ATTACHMENT 3

PROPOSED TECHNICAL SPECIFICATION CHANGES

MILLSTONE 1, RELOAD 7

SEPTEMBER, 1980

Figure 11.1f - MAXIMUM AVERAGE PLANAR LINEAR HEAT GENERATION RATE (MAPLHGR) VERSUS PLANAR AVERAGE EXPOSURE. FUEL TYPE P8DR265H.

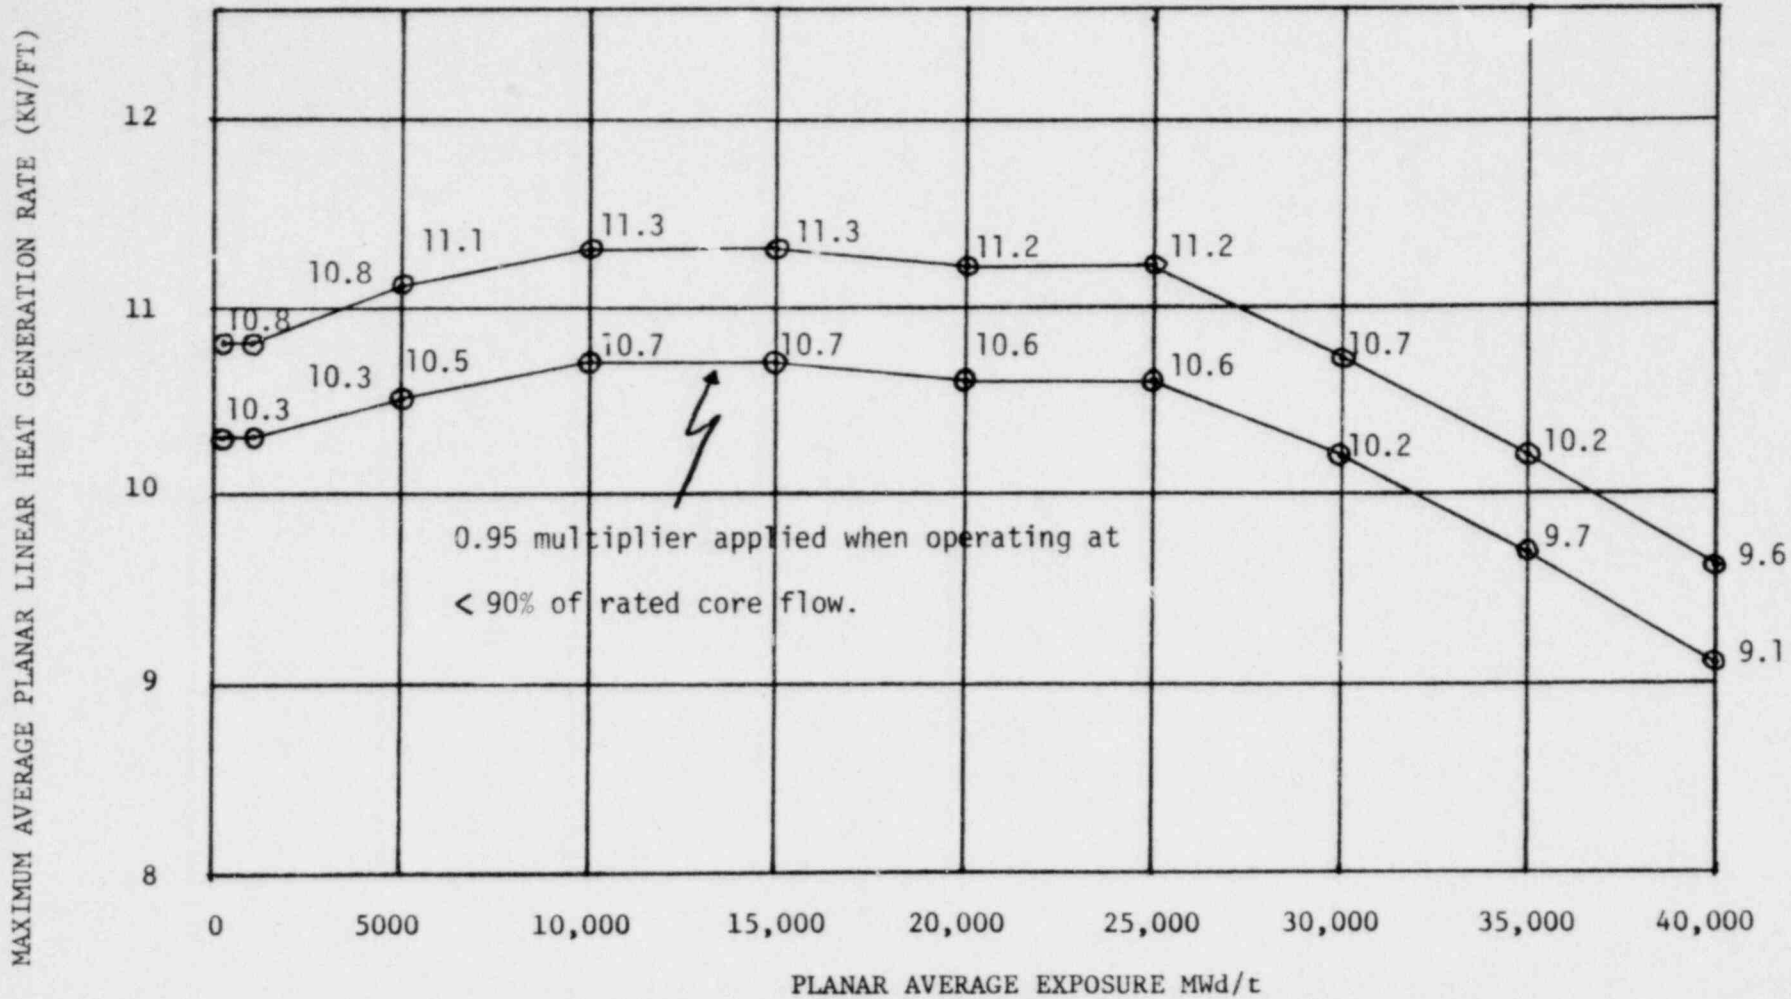
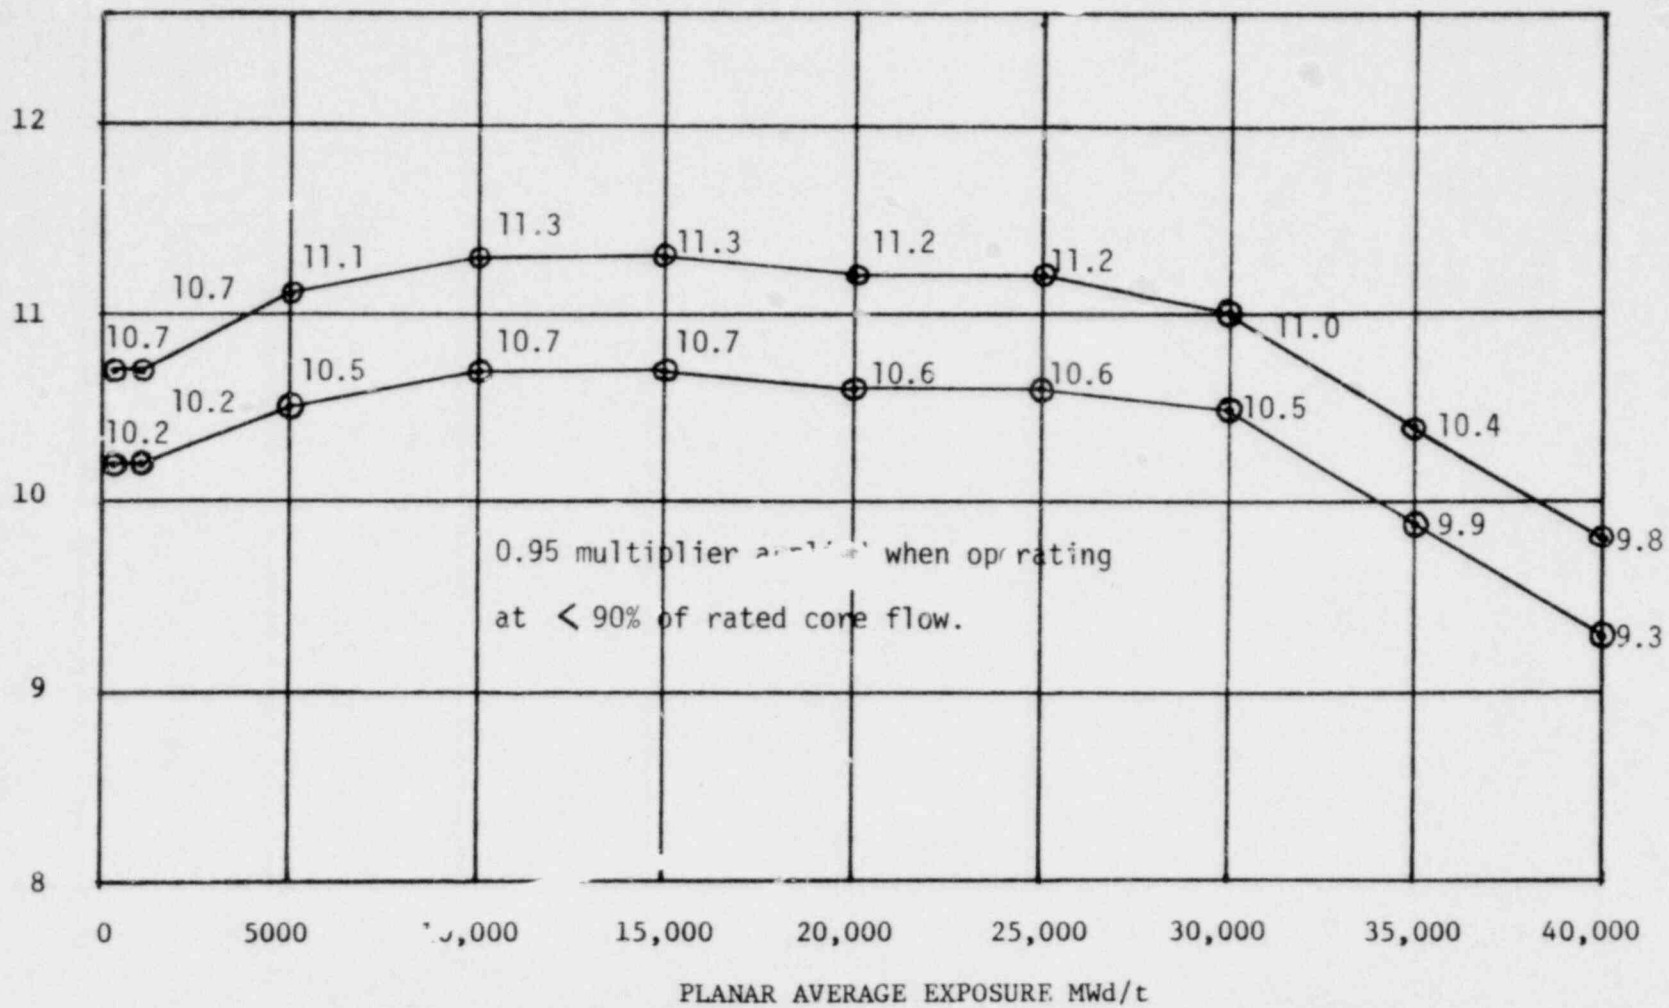
The Maximum Average Planar Linear Heat Generation Rate limits proposed herein, are based on accident analysis performed with the Cycle 8 core. The limits are supported by the enclosed topical report, NEDO-24085-1 (Attachment 2).

The existence of a gas turbine emergency power supply instead of a second diesel makes Millstone Unit No. 1 unique with regard to single-failure considerations in the LOCA analysis. Accordingly, the entire recirculation line break spectrum (both large and small breaks) has been analyzed in NEDO-24085-1, and reference to a lead plant is not necessary.

The small break analysis is consistent with the current Technical Specification bases contained in Amendment No. 67 to License No. DPR-21, transmitted by letter dated May 8, 1980, D. M. Crutchfield to W. G. Council. The addition of a fourth ADS valve to improve depressurization and reflooding capability is the only significant change.

1. During power operation, the APLHGR for each type of fuel as a function of average planar exposure shall not exceed the limiting value shown in Figure 3.11.1.
2. If at any time during operation it is determined by normal surveillance that the limiting value for APLHGR specified in Section 3.11.A.1 is being exceeded, action shall be initiated within 15 minutes to restore operation to within the prescribed limits. If the APLHGR is not returned to within the prescribed limits within two (2) hours, the reactor shall be brought to the Cold Shutdown condition within 36 hours. Surveillance and corresponding action shall continue until reactor operation is within the prescribed limits.
